## SITE PLAN REVIEW AND APPEARANCE BOARD

Meeting: January 13, 2021 | File No: 2020-183-SPF-SPR-CL5 | Application Name: The George

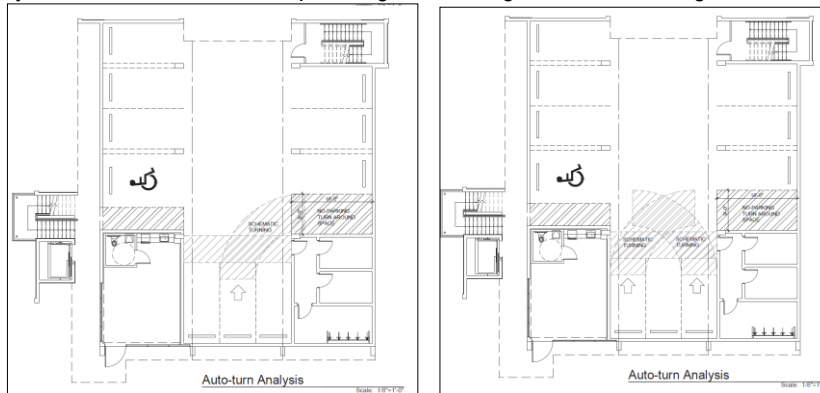
- Sheet SP-1 shows a 22' wide drive two-way aisle entering the property increasing to a 24' wide drive aisle adjacent to the 90° interior parking spaces in accordance with the LDR section.

- Sheet SP-1 shows 5 parking spaces provided adjacent to a proposed 20' wide improved alleyway. The plans show that the spaces and the alleyways will have a combined depth of 42', and the spaces will be at least 10' wide in compliance with the LDR section.

- Sheet SP-1 shows three compact spaces within the covered parking area. The plans show that the spaces will have two striped backout areas: (1) 6'x24' and (1) 9'-4"x18'. The plans include signed and sealed auto-turn analysis that demonstrate adequate ingress and egress maneuvering of the dead-end parking spaces.
